## Elements Seeking Consent:

396-109

## PROPOSED SECTIONS

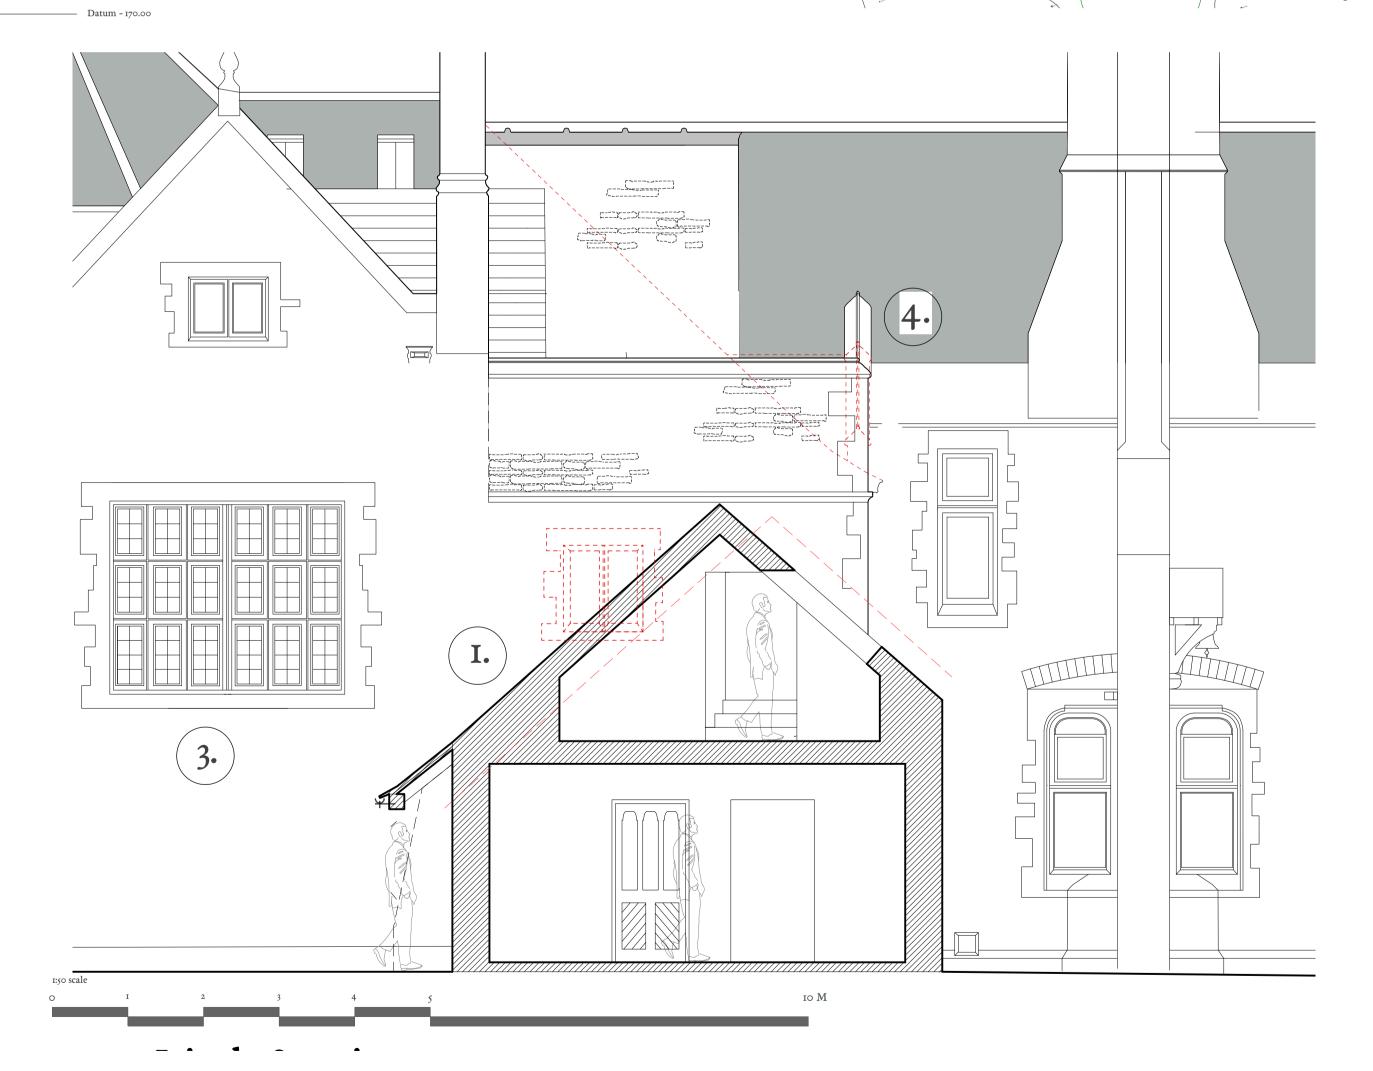
- Minor changes to external cladding details and minor internal changes to consented extension
- Reinstatement of Lutyen's Porch (reduced size)
- Reinstatement of Lutyens' leaded lights to front mullion windows
- Minor change to parapet detail
- Reinstatement of stone mullions to Lutyens' bay
